Federal Register

[Docket No. FAA-2019-0715; Product Identifier 2019-NM-151-AD; Amendment 39-19760; AD 2019-20-07]

Airworthiness Directives; The Boeing Company Airplanes

ACTION: Final rule; request for comments.

Figure 2 (Sheet 1 of 3) Slat and Flap Inspection

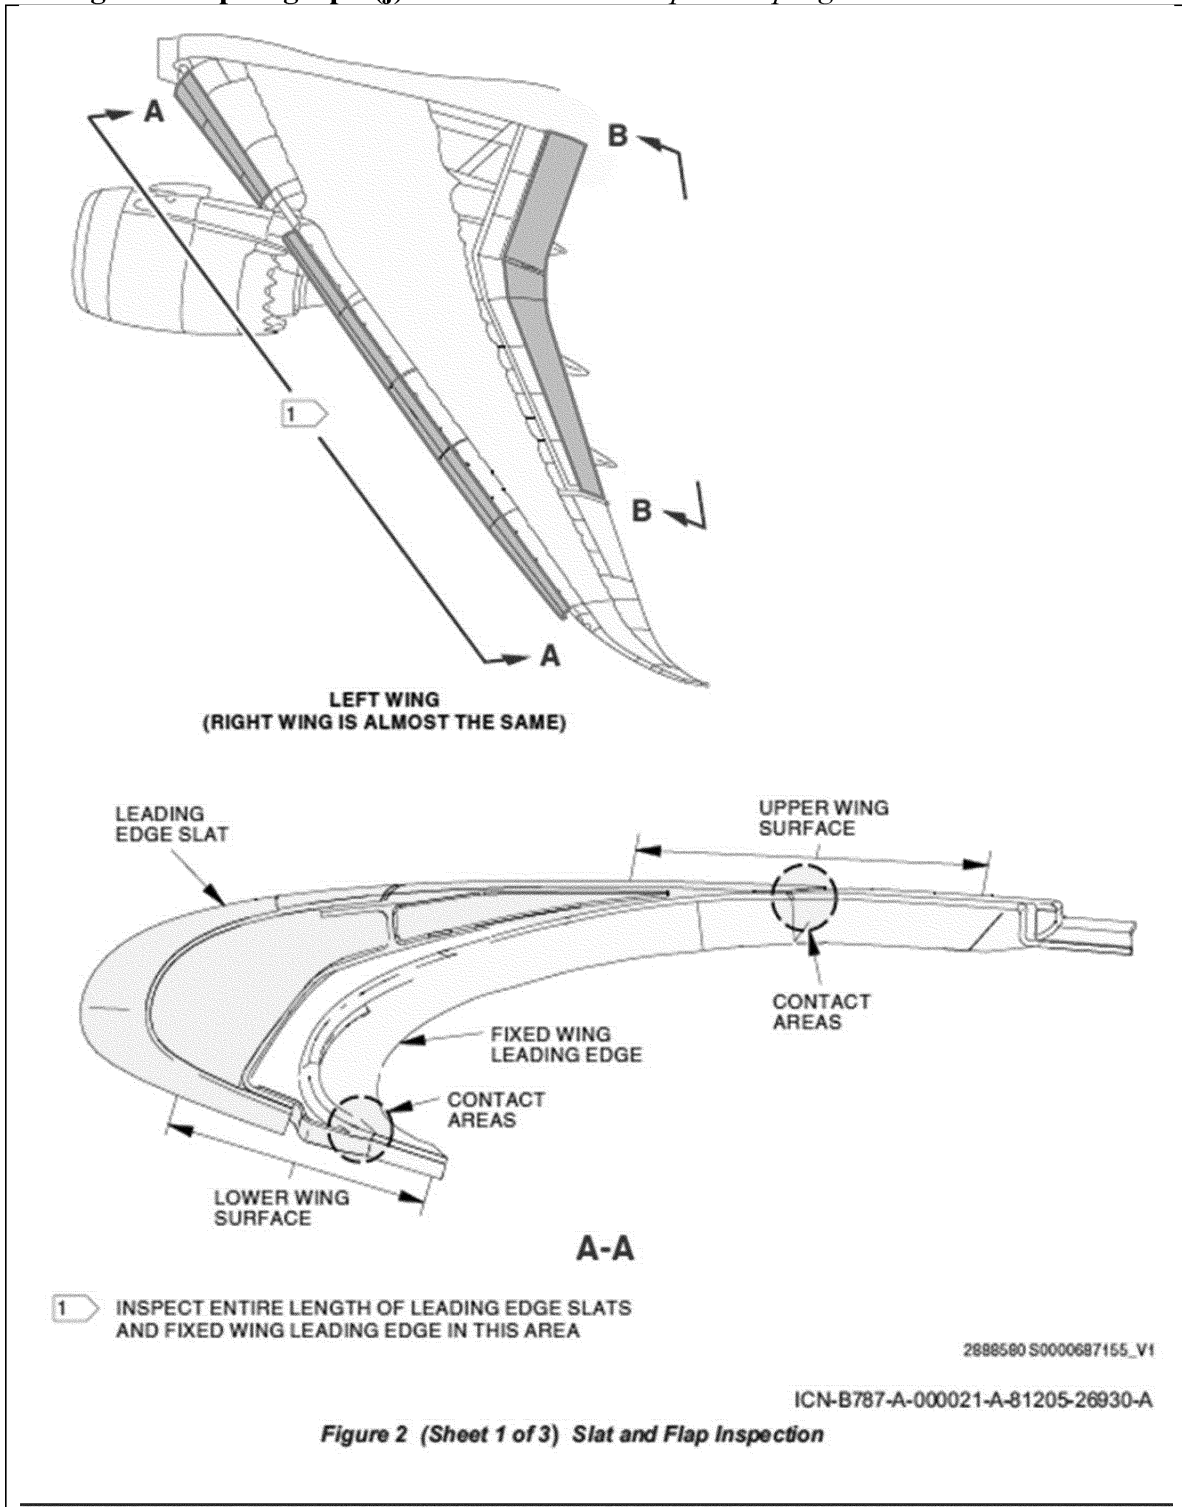
After any landing in icing conditions, do this inspection with the slats/flaps (flaps 25 detent) fully extended (Figure 2):

- (a) Examine these areas for contaminants (ice, snow, slush):

- 1) Slats/flaps surfaces
- 2) Leading edge contact surfaces

- 3) Slat actuation areas, including exposed areas of the slat track cavity, and slat cove
- 4) Flap tracks, hinges, seals

- (b) Remove the contamination that you find.
